PRODUCT CHANGE NOTIFICATION

Bourns® Model SA2 Gas Discharge Tube Series

Changes to Reel Hub Packaging

GDT2326

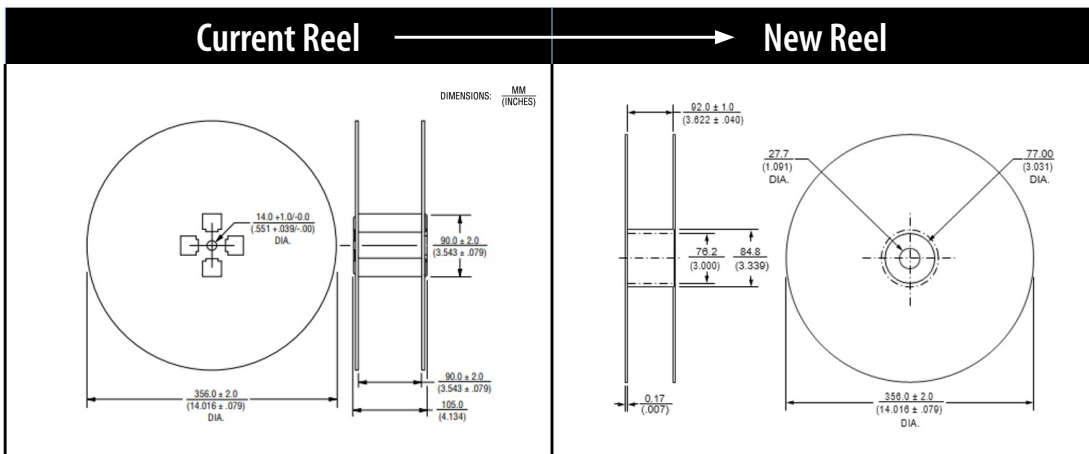
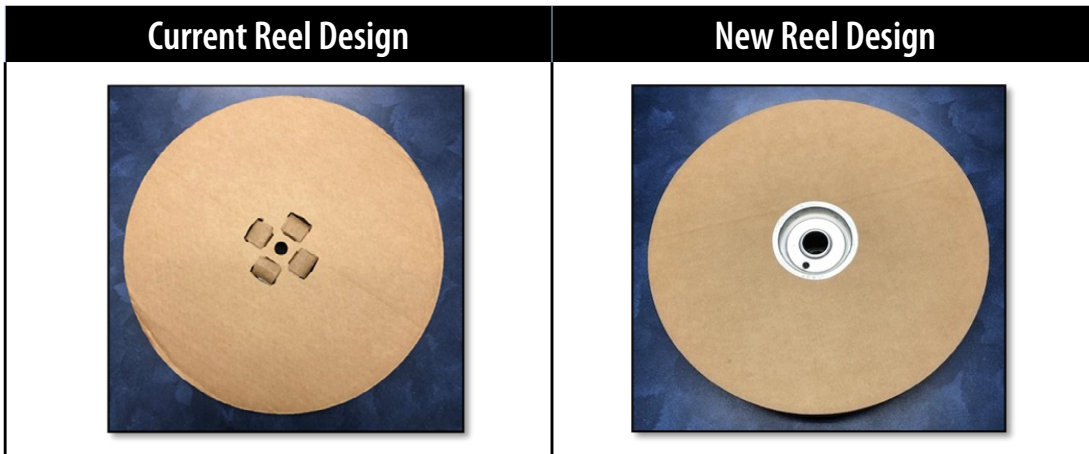
Riverside, California – June 6, 2023 – In the spirit of continuous improvement, effective August 15, 2023, the reels used to pack select Bourns® [Model SA2 Series Gas Discharge Tubes](#) in their axial leaded tape and reel packing configuration will change to a plastic or metallic (optional) hub. This change will minimize the friction between the support shaft and the reel in automatic lines, decreasing the tension in the tape and thereby optimizing performance. This change will also reinforce the reel structure.

This change in the reel's hub will have no effect on the form, fit, function, quality, or reliability of the products themselves. A list of affected part numbers is provided below.
